# WOLF CREEK

WO 96-0037

Subject: Docket No. 50-482: Response to Request for Additional Information Concerning the Revision to Technical Specification 3/4.8.1, "Electrical Power Systems - A.C. Sources"

### Response to Request for Additional Information

Figure 4  
Single-Load Rejection Test (followed by ESW pump start)  
(Page 1 of 1)

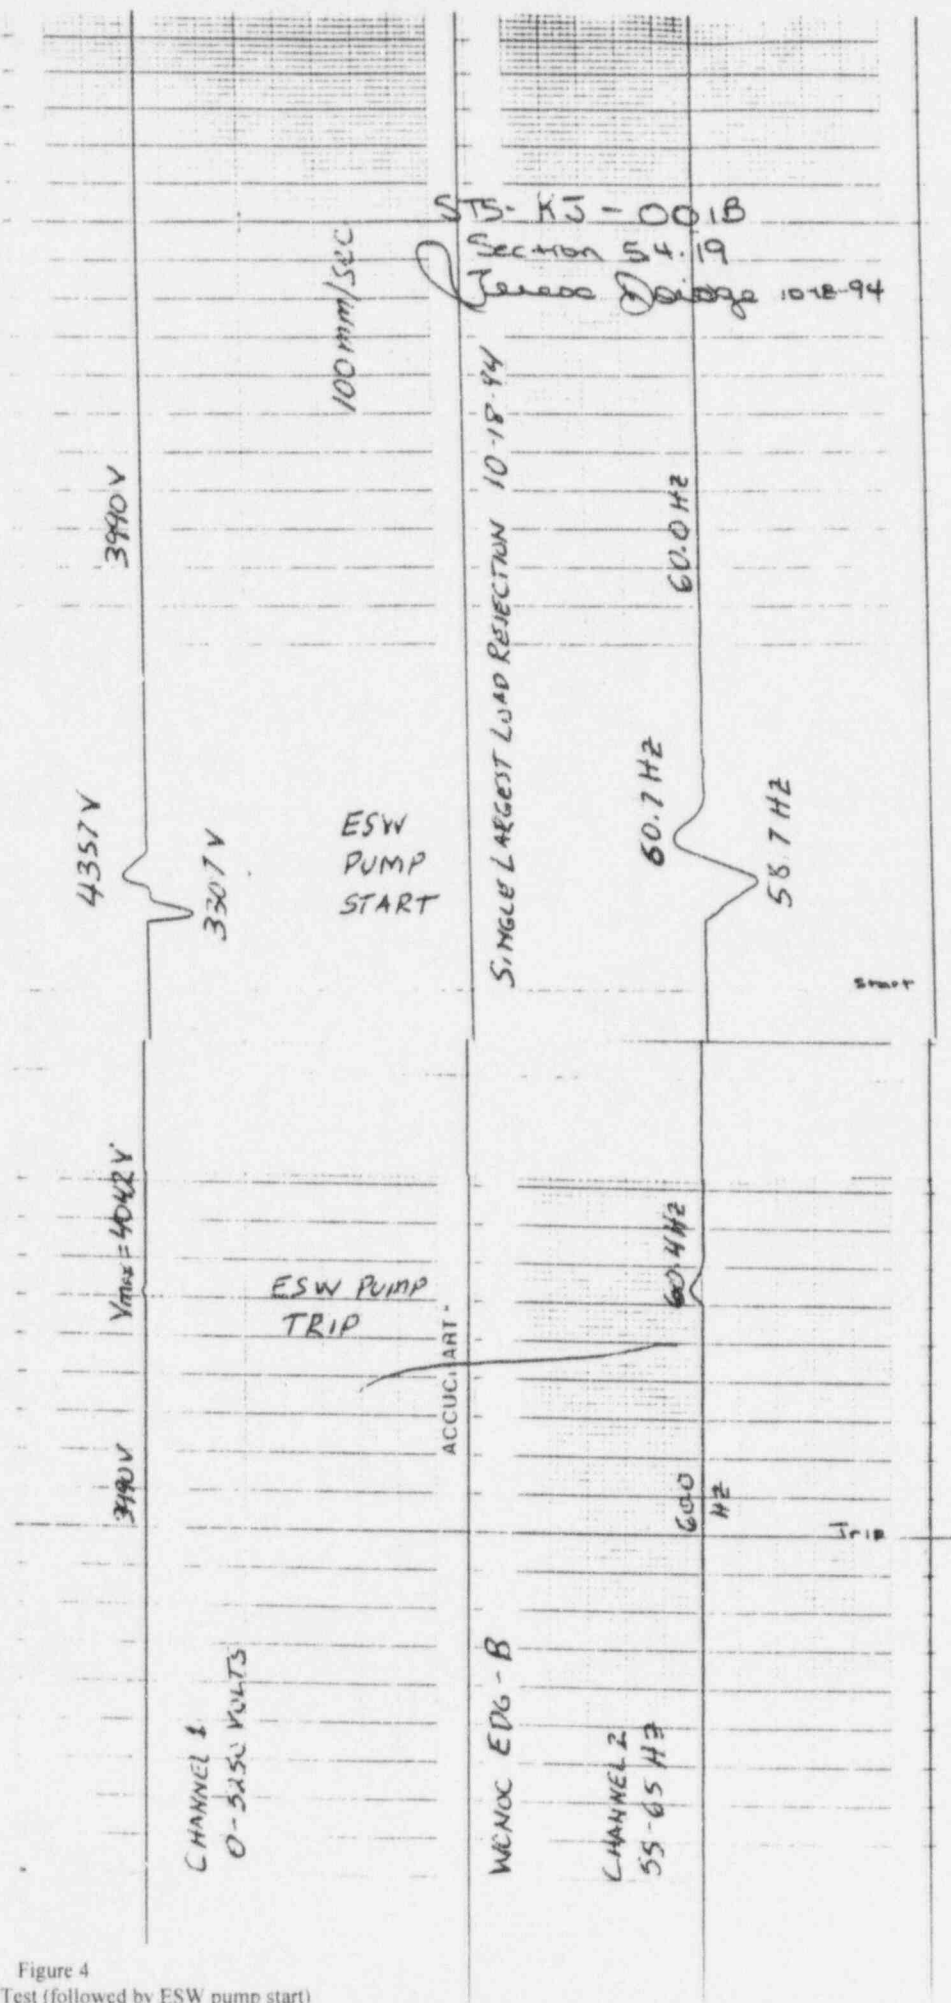
NRC Comment 3. Provide additional justification for removal of Surveillance Requirement 4.8.1.1.2g.2, single-load rejection test, from Technical Specifications.

The voltage and frequency swings for the single-load rejection test at WCGS and Callaway Plant stay within steady state values at all times in the transient. The voltage and frequency swings that occur during the load sequencing are much greater than the swings during the rejection and indicate that the connected loads can handle the transient of the single-load rejection. Figure 3 provides a strip chart recording for the Callaway Plant that is typical of the "Blackout Load Sequencing the ESW Pump Load Rejection Tests." It indicates that the sequencing load transients are of a much greater magnitude than the Essential Service Water (ESW) pump load rejection. The voltage and frequency swings shown on page 4 of Figure 3 for the ESW pump start, show a minimum of 3323 Vac to a maximum of 4600 Vac for the voltage transient and a minimum of 58.2 Hertz to a maximum of 61.1 Hertz for the frequency transient. The
